File 1991-0076

Name: Sperber Lane Subdivision and ROW Vacation

SPERBER LANE MINOR SUBDIVISION  
FILE # 76-91

# SPERBER LANE MINOR SUBDIVISION

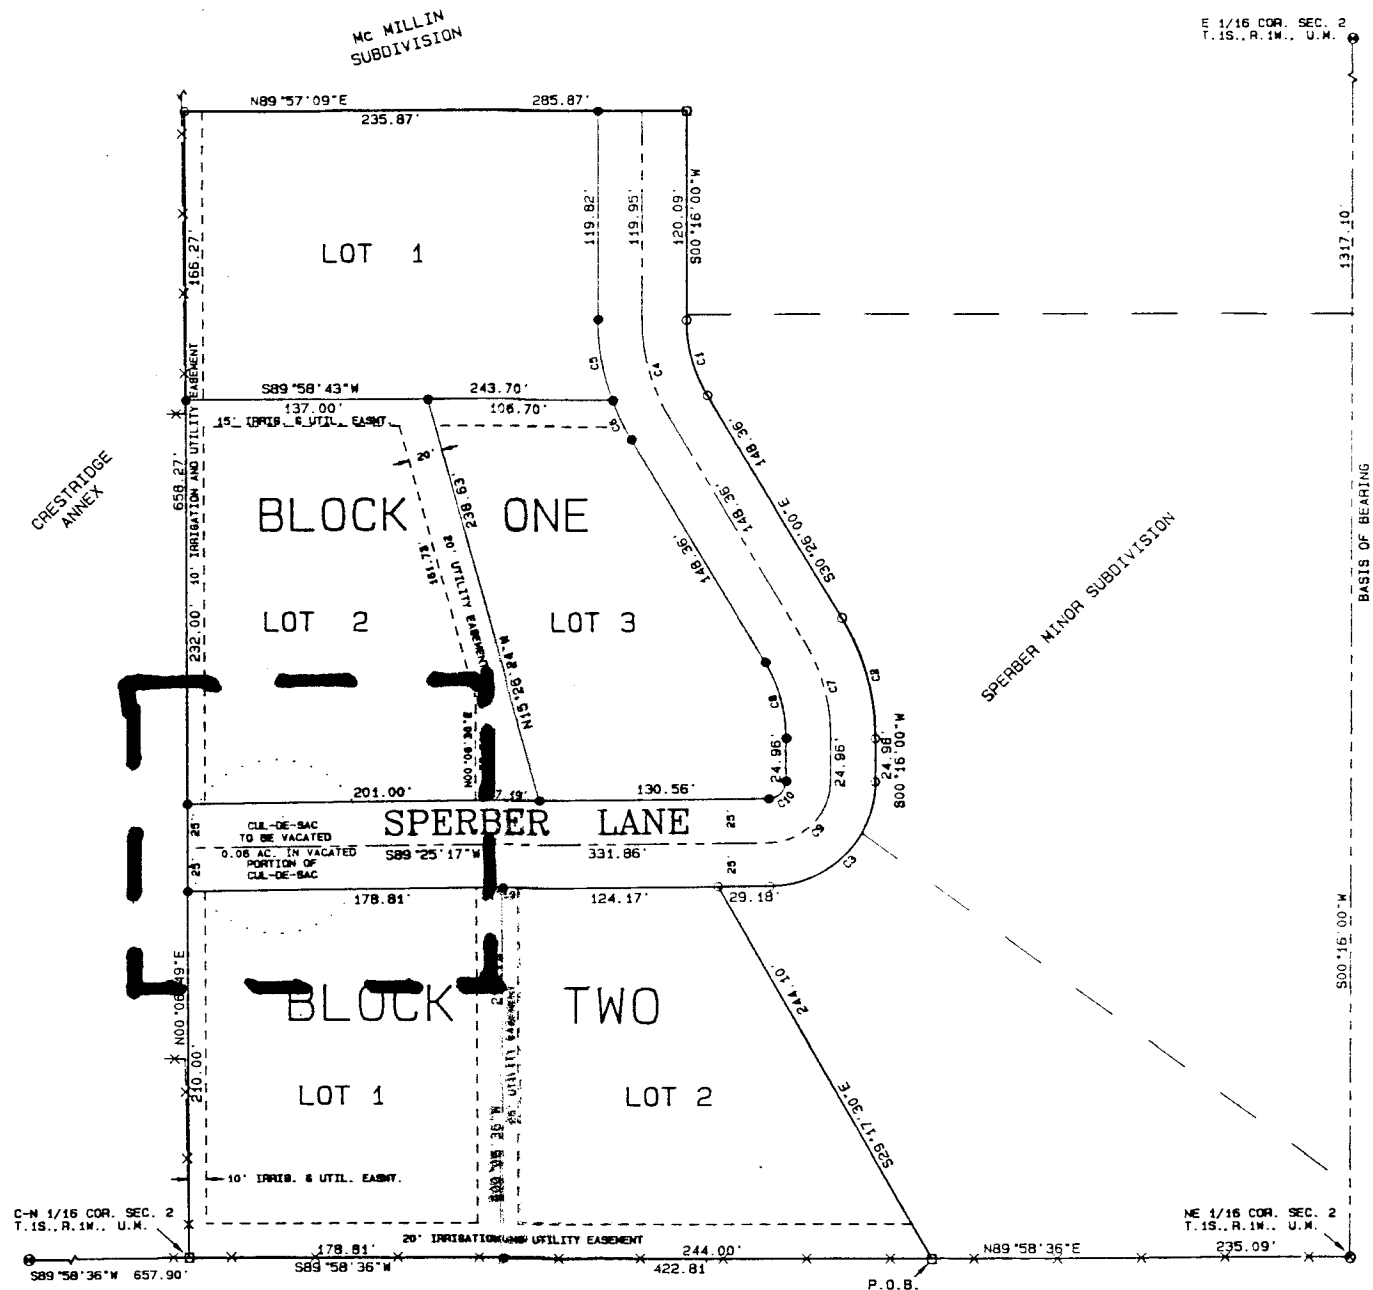
1. Existing chip and seal is not adequate. City Engineer requires that the road be reconstructed full width along the frontage of lots 1, 2, and 3 to the proposed rural road standard. Rural Standard is a 24 ft wide pavement width. Thickness depends on existing base thickness.

2. Requires changing the radius on the horizontal curve at the Southeast corner of lot 3 to meet minimum requirements for a turning roadway.

3. A new culvert is required where the drainage from lots 1, 2 and 3, Block 1 crosses Sperber Lane. Drainage easement is required from Sperber Lane south to drainage.

4. A Street light is required on the horizontal curve at the Southeast corner of lot 3.

# SPERBER LANE MINOR SUBDIVISION

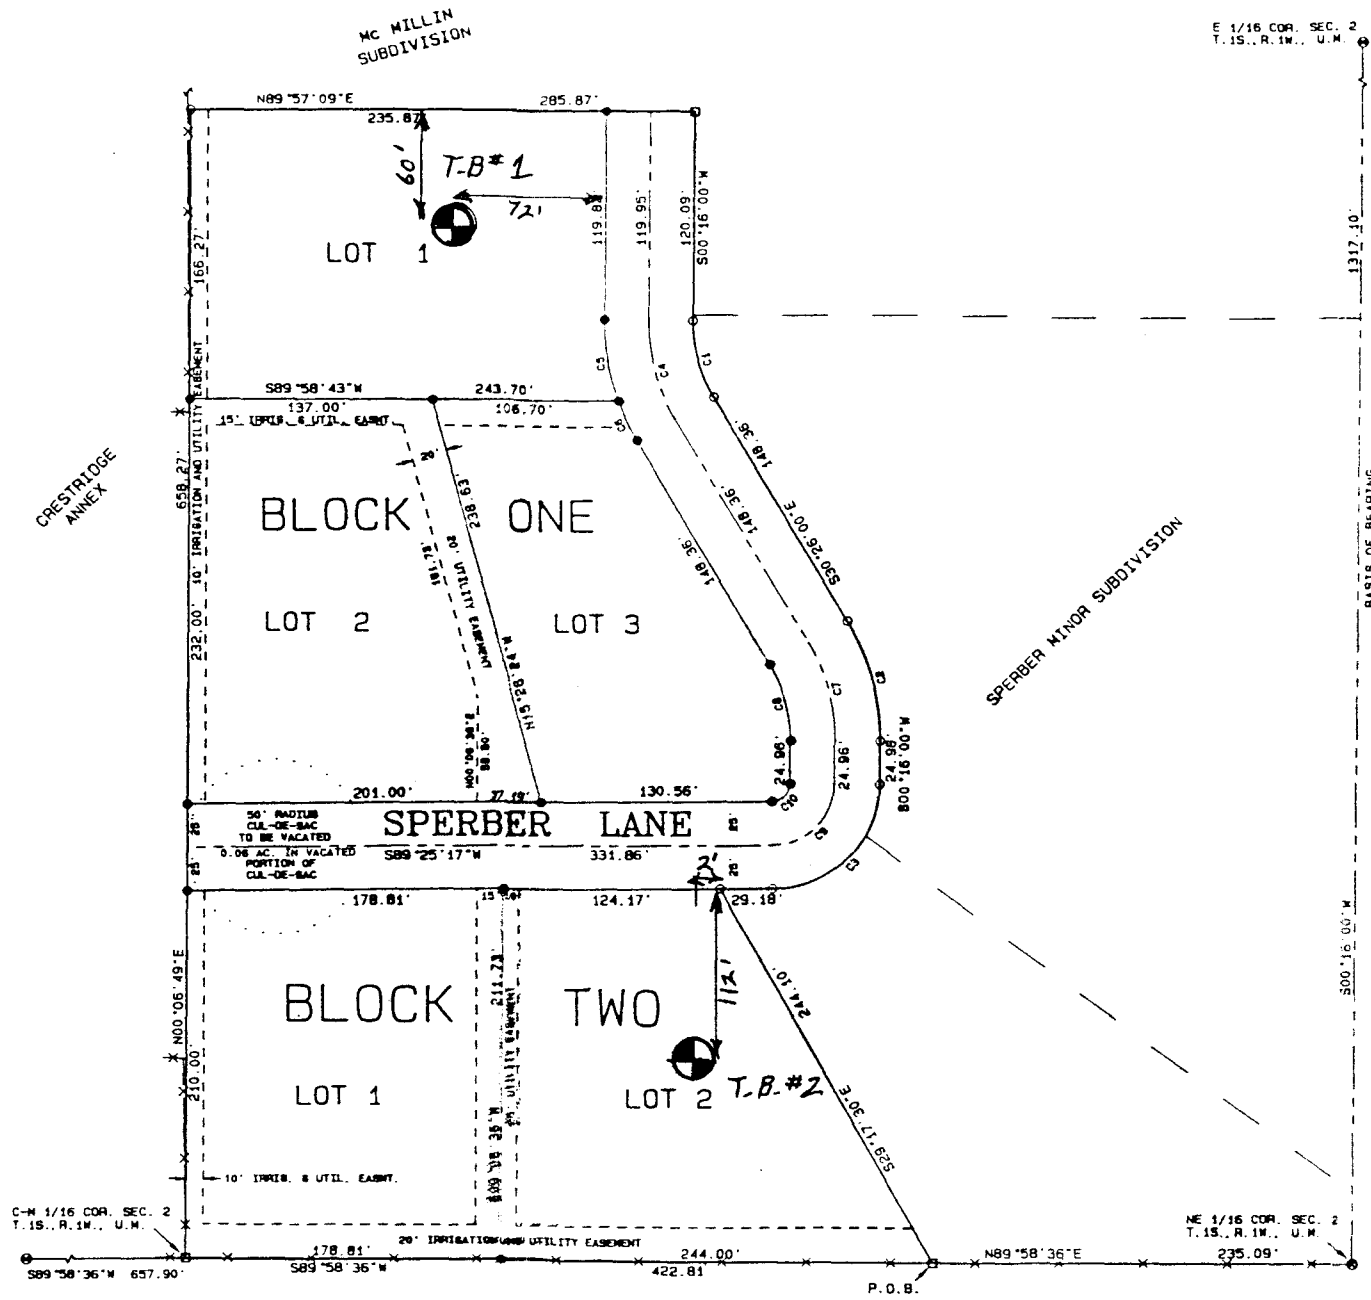
Water: Show location of water line in Sperber Lane that provides service to Lot 1.

Irrigation: What type of irrigation is being proposed for the added lots?

1. A benchmark showing the elevation is required on the plat.
2. Surveyors certificate needs to track code, see Code section 6-8-2A.1.b.
3. All requirements of recording the final plat apply.
4. Open space fees are due prior to recording.
5. No objection to the right-of-way vacation.
6. One streetlight is required at the southeast corner of Lot 3.
7. SEE Engineer's comments as per road improvements.
8. An Improvement Agreement for road/streetlight/etc. improvements is required prior to recording and will be recorded with the plat.

9. An Improvements Guarantee is required prior to recording.
10. What type of irrigation is being proposed?
11. Where is the water line that will service Lot 1, Blk 1.
12. Remove Utilities Coordinating Committee Certificate from the plat.

1. Surveyors are doing this
2. Surveyors are doing this
3. All okay
4. Will do
5. N/A
6. It is my understanding Public Service does this by city request when area comes in the city. I would just as soon not have one in the area.
7. Engineer said the road should be improved. There is only one area where it has deteriorated and it is where traffic has cut the corner and let water under the oil. This can be repaired. The rest is still in very good shape as we do have a letter approving the road in 1990. There is also 3 other people that would be involved. The radius on the curve has been a roadway since 1962. At this time, it could be a problem correcting it. Sperber Lane is only about 1,800 feet long; therefore we do not get much traffic on it.
- 10-11. All items Mr Cheney needs has been taken care of.
12. Surveyors are taking care of this.

Irrigation:  
Irrigation water shall come from ditch to West of lots  
Banner has taken care of where water line goes on lot 1  
and engineers stamp
